UNITED STATES PATENT AND TRADEMARK OFFICE

APPLICATION NO.	FILING DATE	FIRST NAMED INVENTOR	ATTORNEY DOCKET NO.	CONFIRMATION NO.
10/083,751	02/25/2002	Yoshihisa Kamiya	44471/270726	2302

Office Action Summary

DETAILED ACTION

Fig. 6

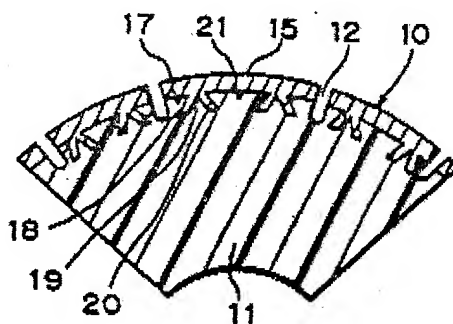
Kanno et al. discloses in Figure #6 a plurality of commutator segments (10) that are arranged externally on the cylindrical surface of the commutator with insulating resin portion (11) having anchors (claws) (20) are fixed to the commutator segments (10); with undercuts (12) formed on the molded resin (conductive material) (11). Figure #8 further discloses anchors (internal claws, that act as anchors) (20A and 20B), extend the length of the commutator segments (10). Furthermore, in Figure #8 a groove (19A-B) are formed on an inner surface and the anchors (20A-B) projecting from the inner surface. Additionally, Kanno et al. discloses in Figure #15 a the grooves (17) and the anchors (20) being extended from a second end of the commutator segment to the end of the first end, in which an end step and an end edge are end at the first end.

Fig. 15

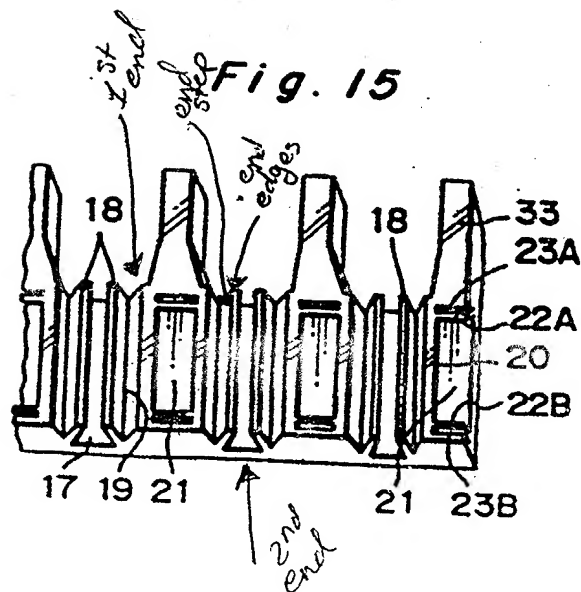
In regards to applicant's argument that Kanno et al. does not recite the amendment of Claim 5, the examiner respectfully disagrees. As stated above in the 102 reject of Claim 5 Kanno et al. discloses in Figure 15 the limitations of "the groove and the anchors being extended from a second end of the segment opposite to the first end and being ended close to the first end by an end step and end edges." Applicant does not disclose what the end edges and end steps are in the drawings or the specification and thus the examiner understands that the end edges and end steps are the ends of the anchors as understood from the wording of the claims. It is advised that the applicant amend the specification and drawings if the examiner is incorrect.

FIG. 2

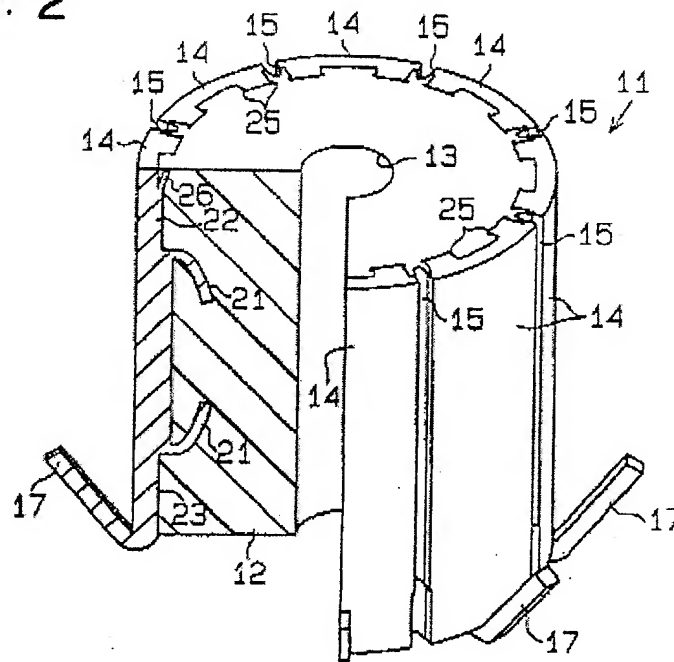
Kageyama et al. illustrates in Figure # 2 hooks (claw) (17) having an inner hooks (anchors-inner claws) (21) bent inwardly and that the anchors is from a proximal end of the hooks which are embedded into the insulation body (12), for the purpose of holding of insulation body at the central portion of the commutator segments.

In regards to applicants argument of Claim 3 Kageyama et al. illustrates in Figure 2 that the second anchors are divided from into two hooks and the internal side of the hook is bent inward as stated in the limitation of the claim. Kageyama does disclose in figure 2 the second anchors projecting inward from a proximal end of the hooks. Kanno et al. discloses in the prior art figures 2-3 second anchors (5A and 5B) that are projecting inwardly from proximal ends of the hook (claw)(A), thus the structural combination of the second anchors and the anchors and the hooks would be obvious to one of ordinary skill in the art.
